Large-Scale Residential Development at Ballybin Road, Ratoath, Co. Meath

Applicant's Response to LRD Opinion
Items 4(b), 5, 6, 10, 11, 13 and 19
(Planning Submission)

2334-DOB-XX-SI-RP-C-0005

June 2024

- Poor Drainage on Site / Groundwater / Permeable Liner
- Permeable Paving and Rain Gardens (flow through structures)
- Soil Type / SAAR / Qbar
- Runoff Coefficients / Catchments
- Longitudinal Road Sections / Ponding
- Attenuation Design

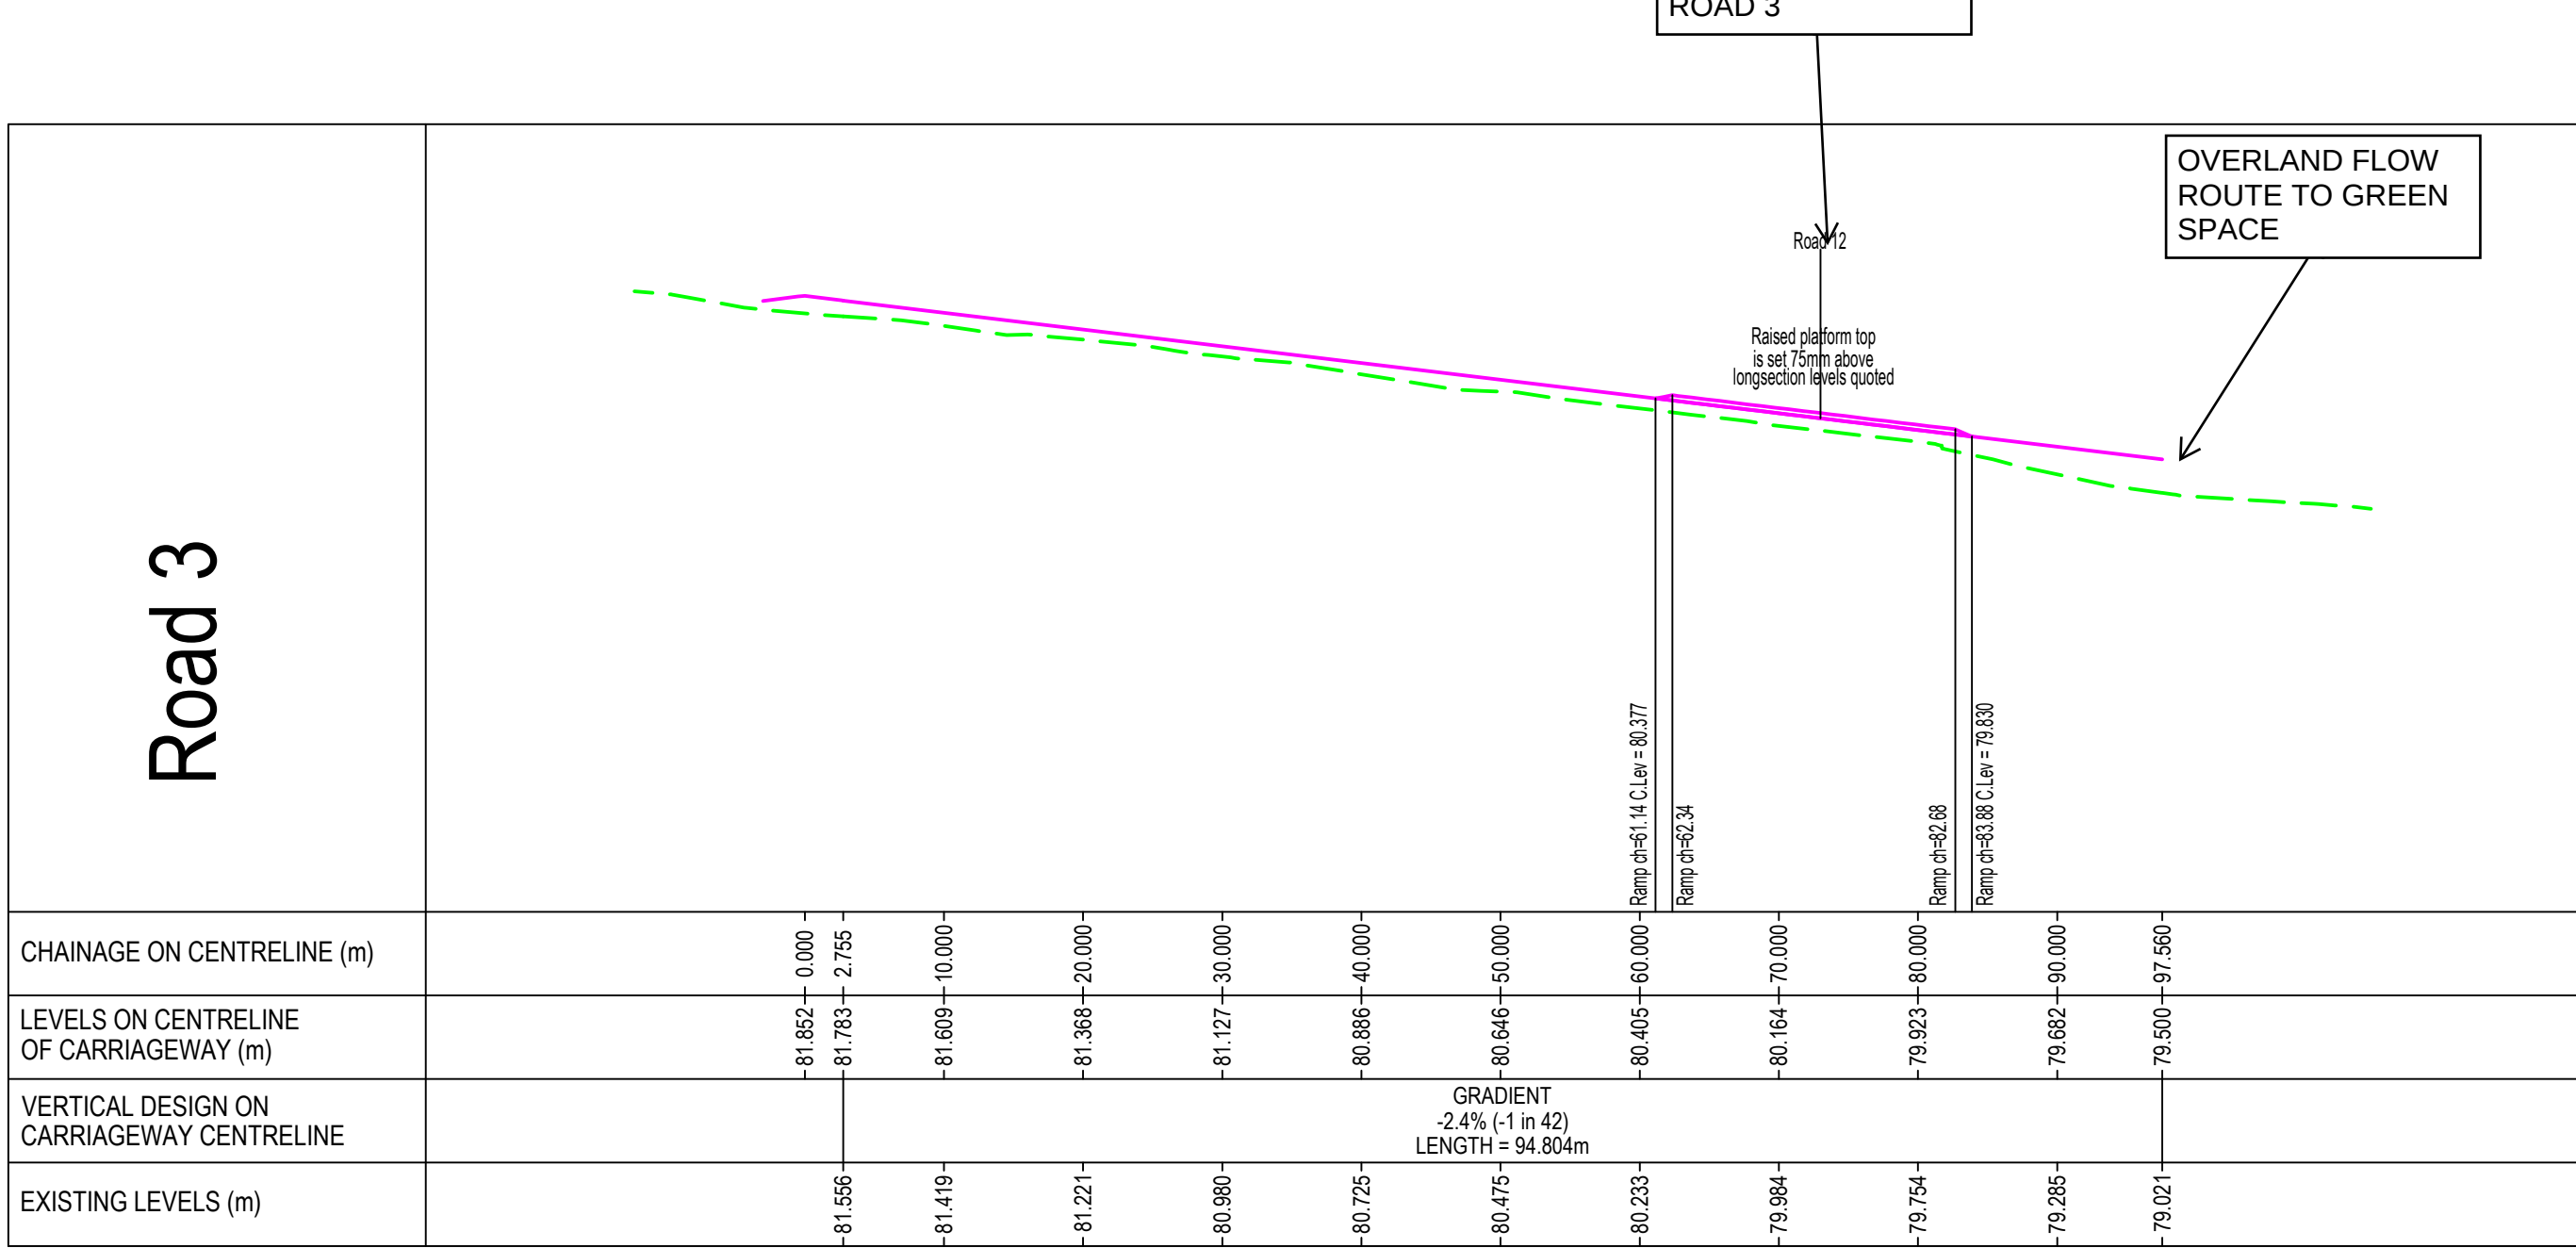
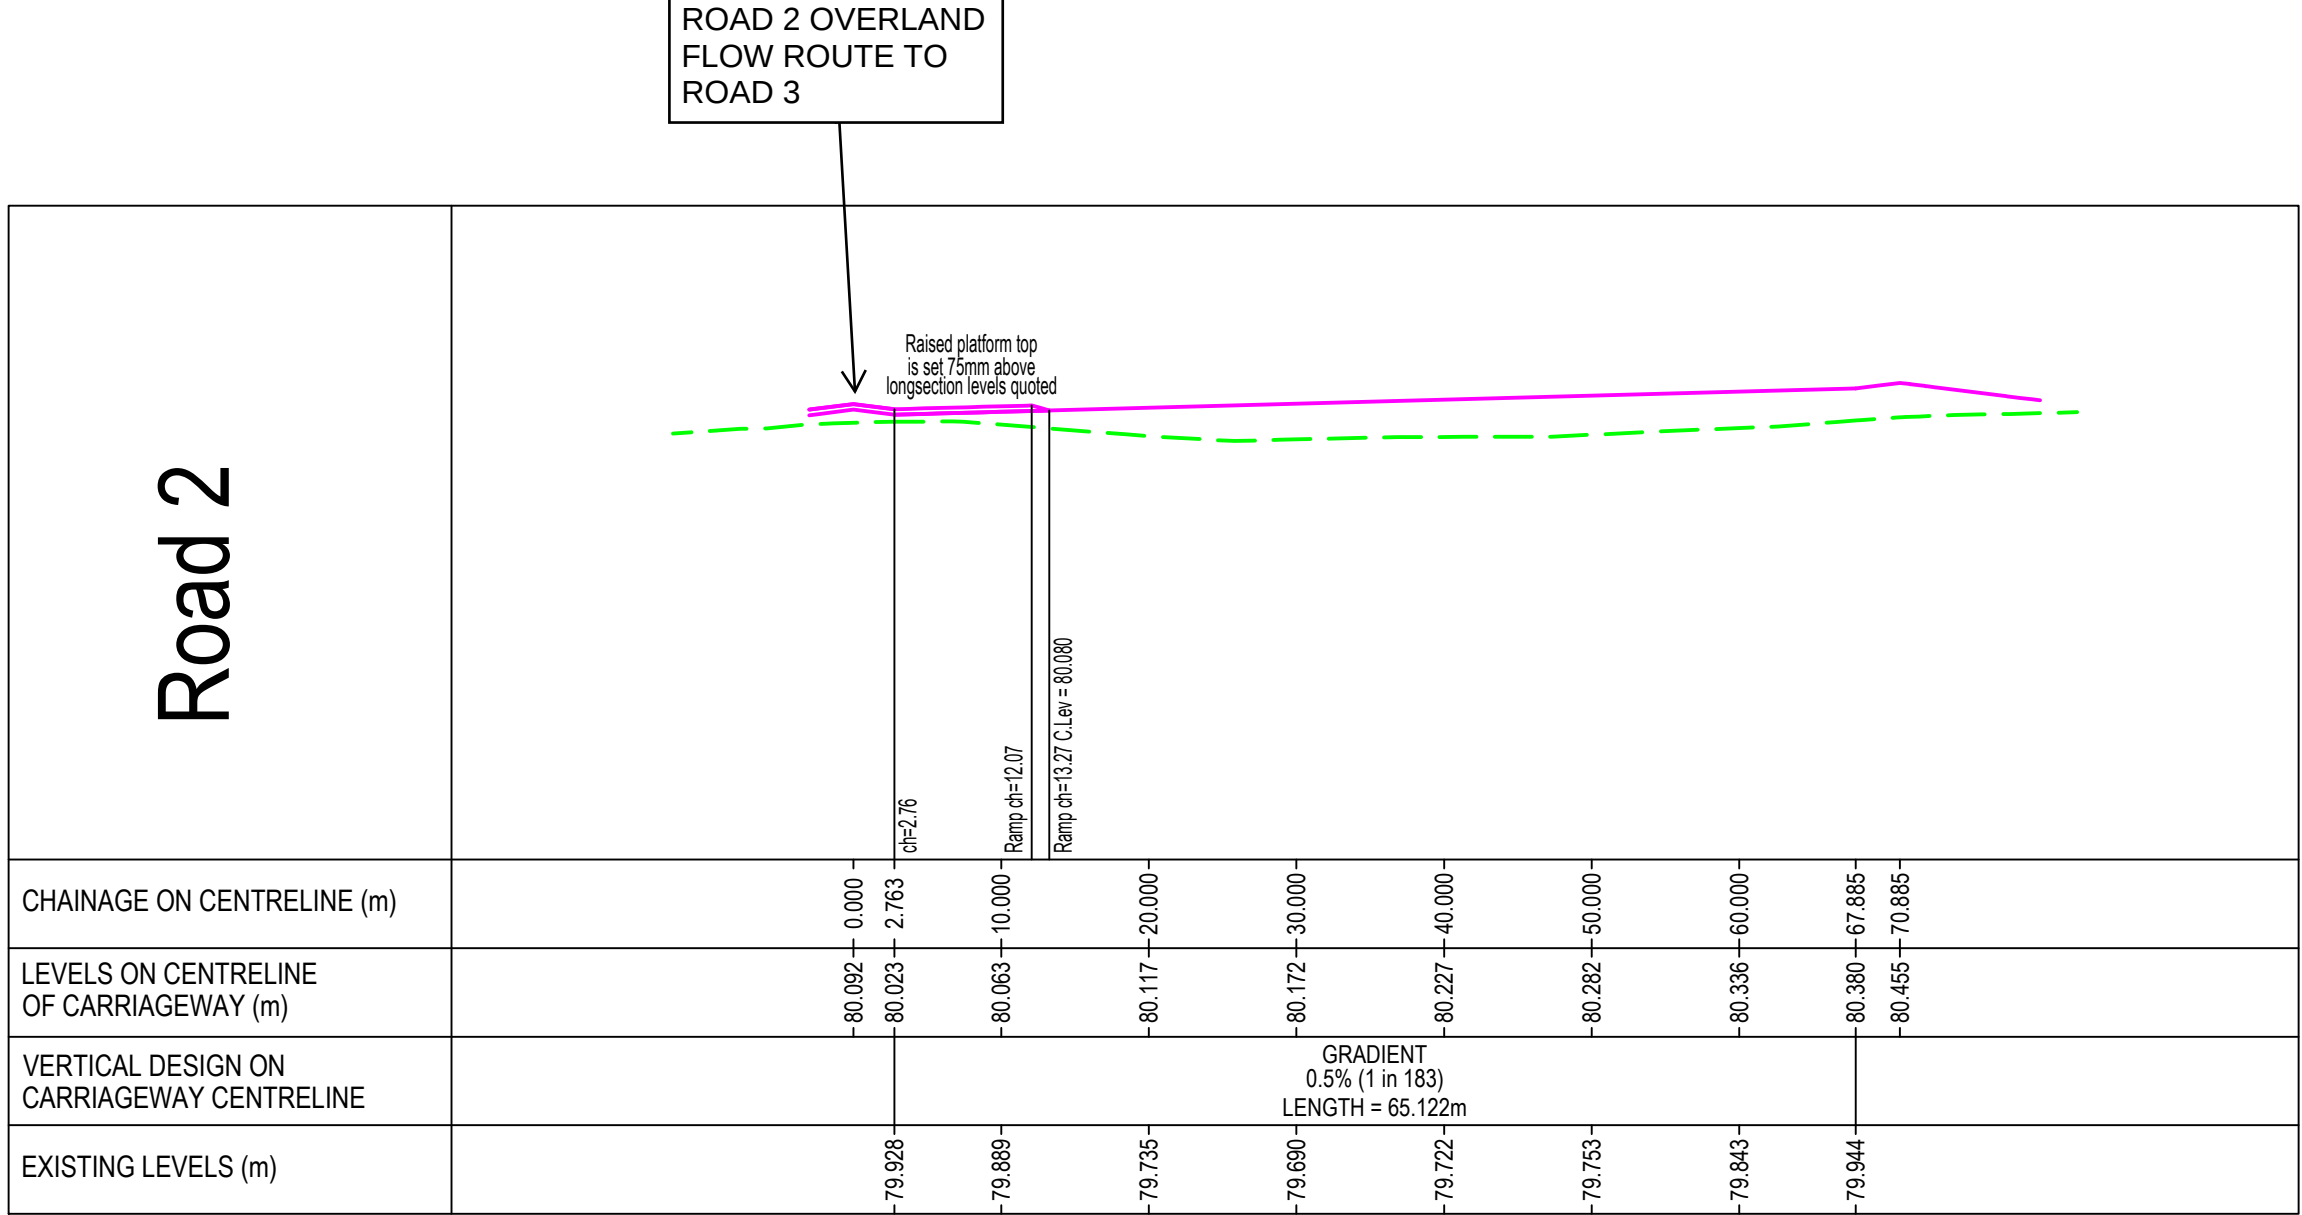
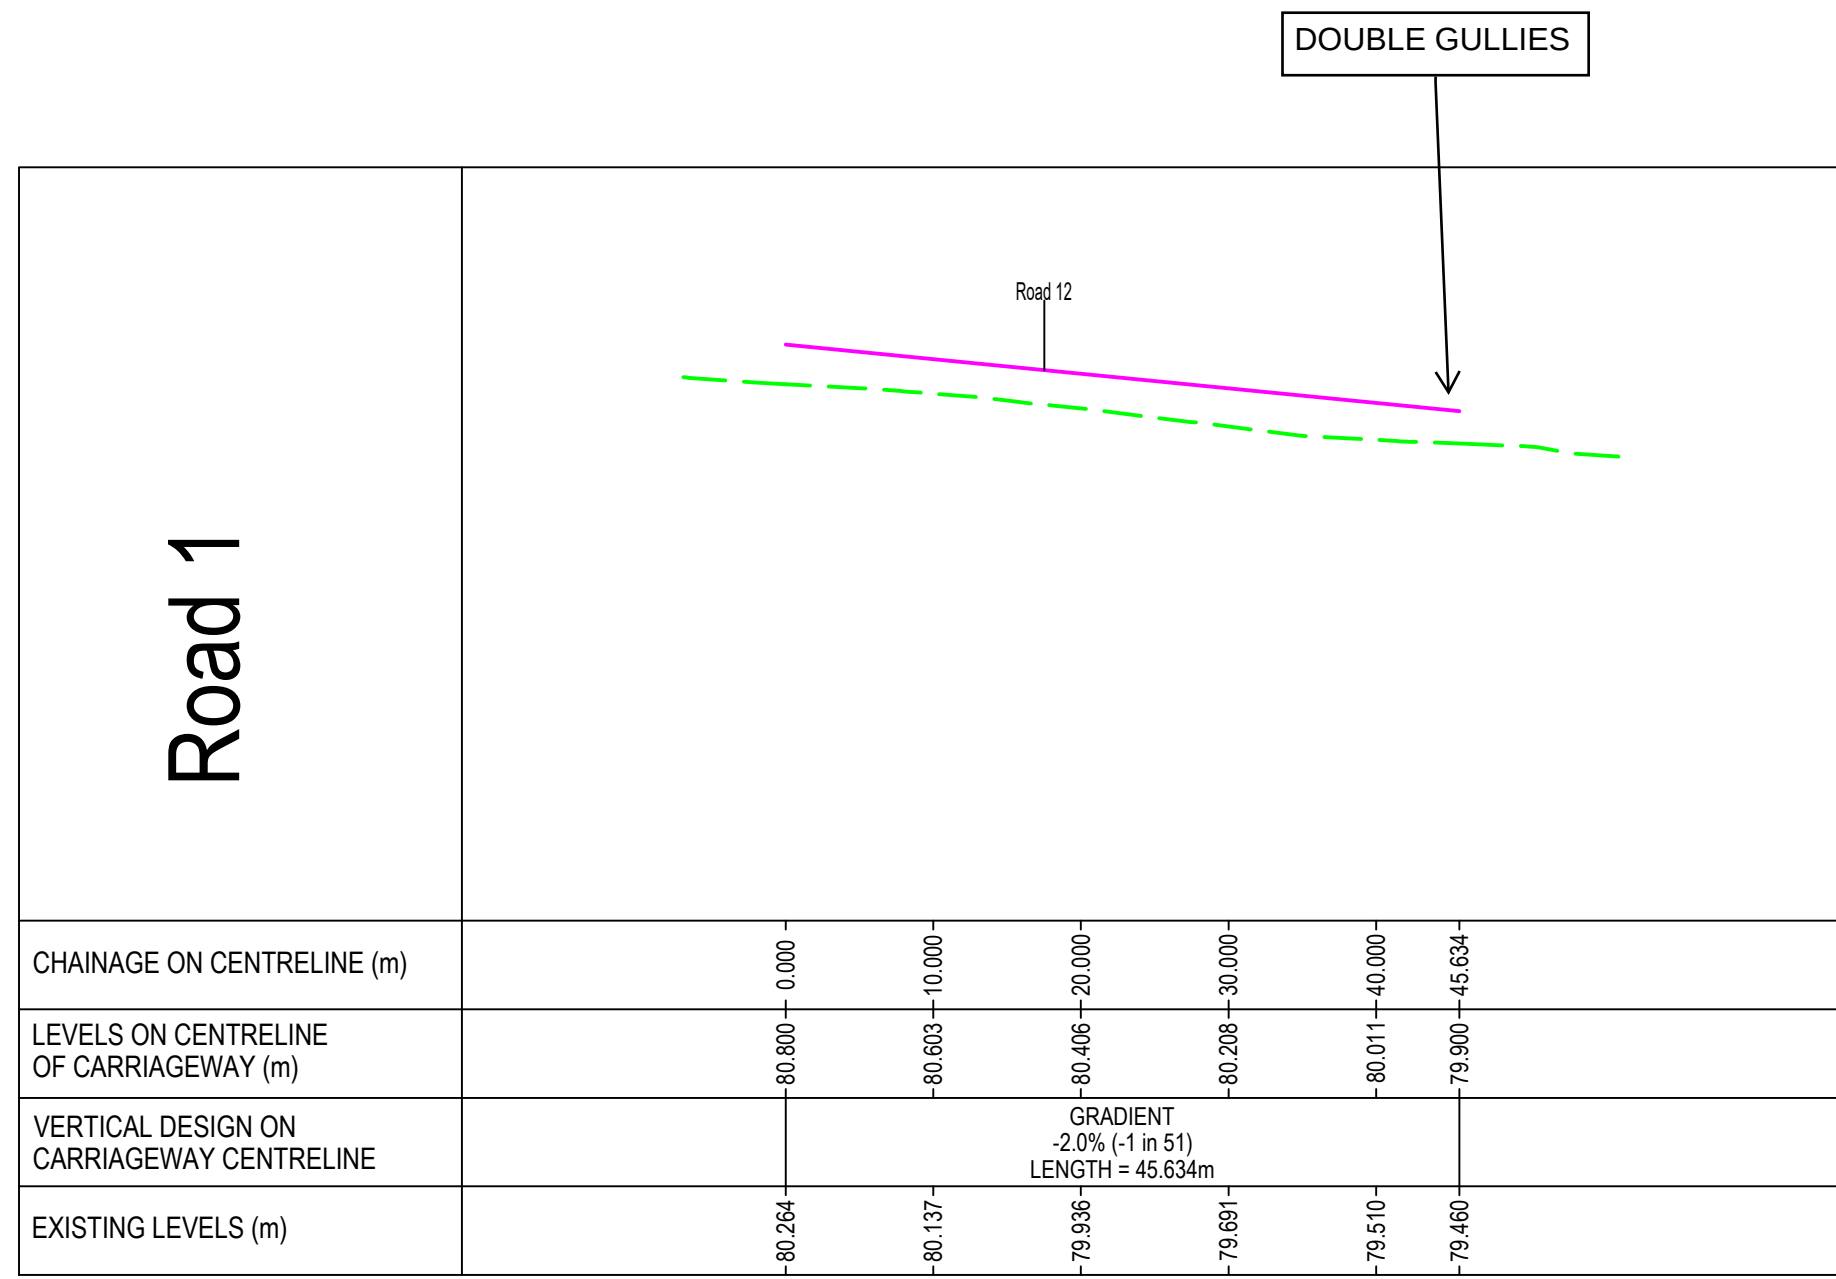
The applicant shall provide confirmation of the catchment area of the adjacent public road and provide details of the sizing of the attenuation system for same.

The proposed attenuation systems detail to be agreed with the Environment Department. It was noted that the proposed attenuation system beside the proposed creche had a potential depth of 1m of water during the 1 in 100-year rainfall event. Max depth of water to be 300mm during the 1 in 100-Impermeable year rainfall event.

The DOBA drawings 2334-DOB-XX-SI-DR-C-0200, 0201 and 0202 submitted under separate cover with the Planning Application documentation illustrate the sub-catchment areas of the adjacent public road. The sizing of the attenuation associated with each sub-catchment is also illustrated on these drawings.

The Applicant would welcome a condition to agree the attenuation system details with the Environment Department post grant of planning. Additionally, the Applicant notes that the design of the proposed scheme has developed since the LRD Opinion meeting and the inclusion of a creche no

longer forms part of the proposals. The updated surface water drainage design includes a maximum 300mm depth of water, not 1.0m, in the deepest detention basin for a 1:100-year storm event including climate change. Please refer to the Surface Water Calculations appended to the DOBA Infrastructure Design Report (IDR) namely 2334-DOB-XX-SI-RP-C-0001 submitted under separate cover with the Planning Application documentation.
